**Planning Commission Meeting Agenda
City of Prairie Village
7700 Mission Road
Council Chambers
Tuesday, May 5, 2026
6:00 PM**

STAFF REPORT

Application: PC 26-01 & 26-11

Request: Rezoning from R-1A to RP-1B and Final Plat

Pond No. 1 - Existing Underground Detention

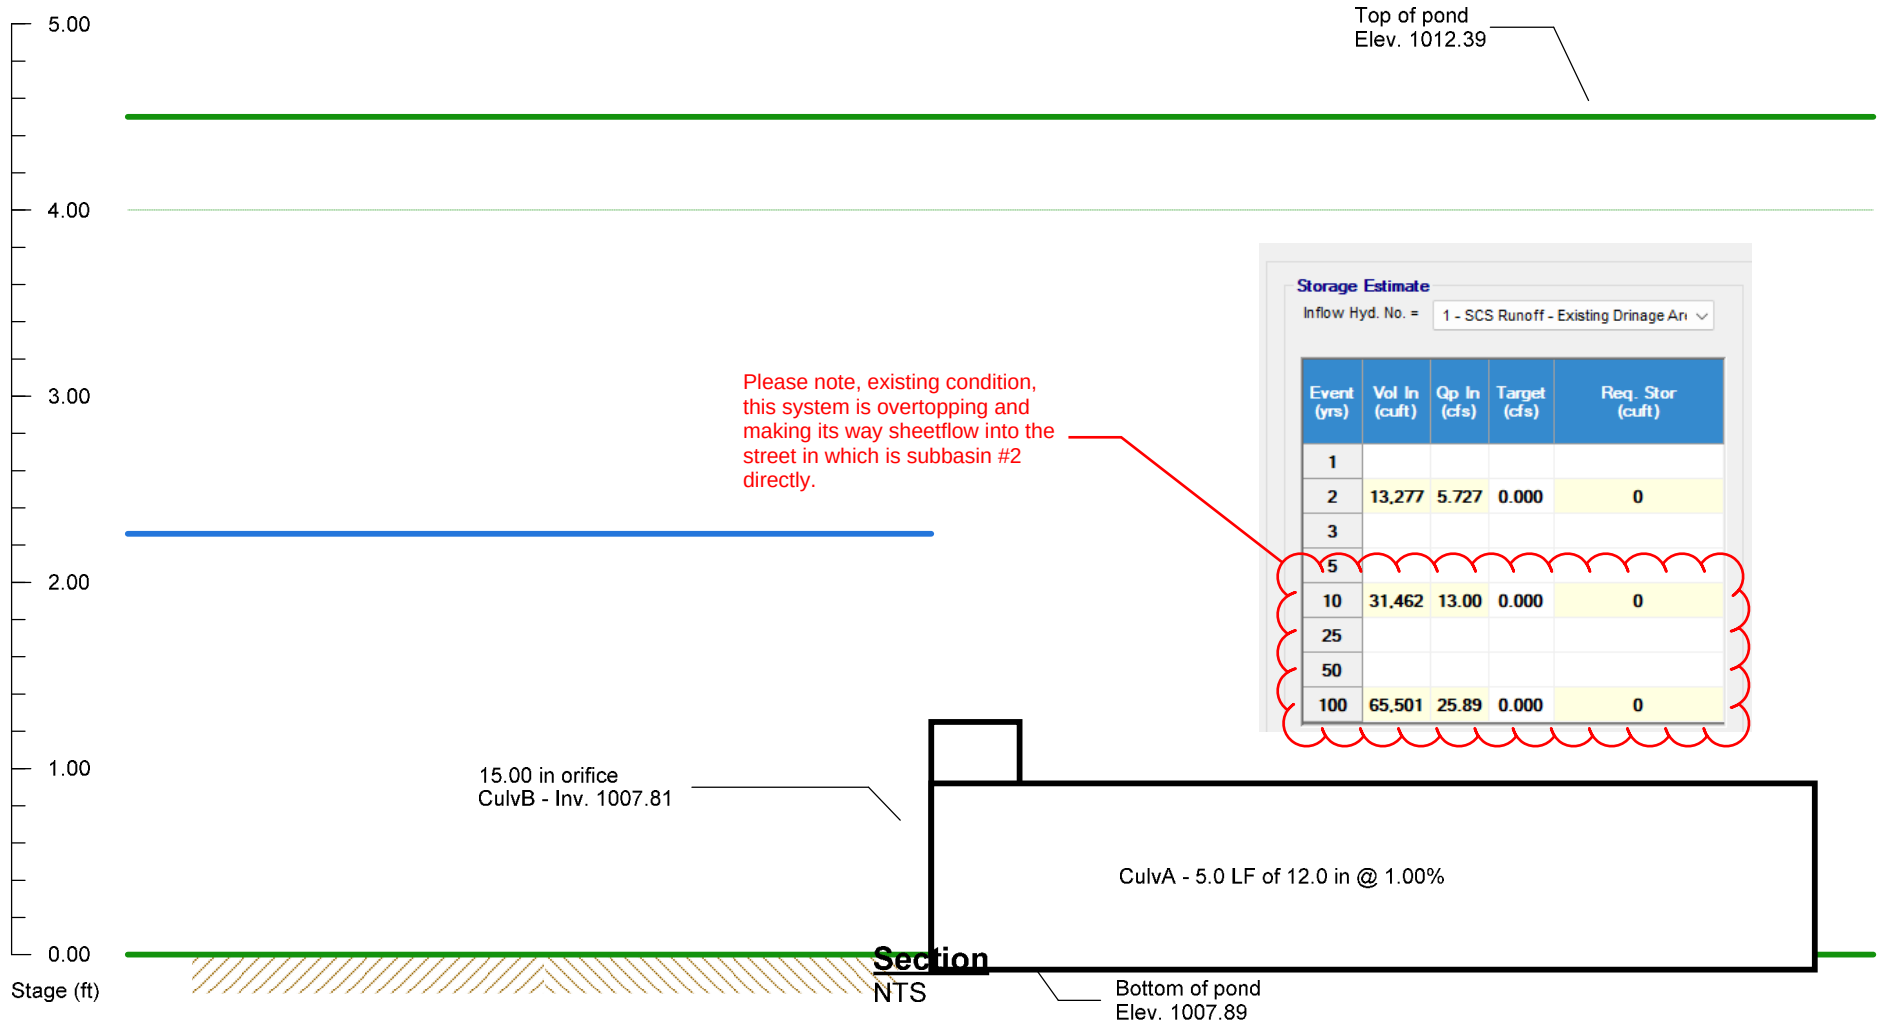
9. Refer to the redline comments regarding the existing drainage area boundary limits for Area #1 and revise accordingly.
10. The detention summary sheet (Page 13) appears to assume a 15-inch outlet. However, the outlet structure was surveyed with a 12-inch orifice plate. Please reconcile this discrepancy.
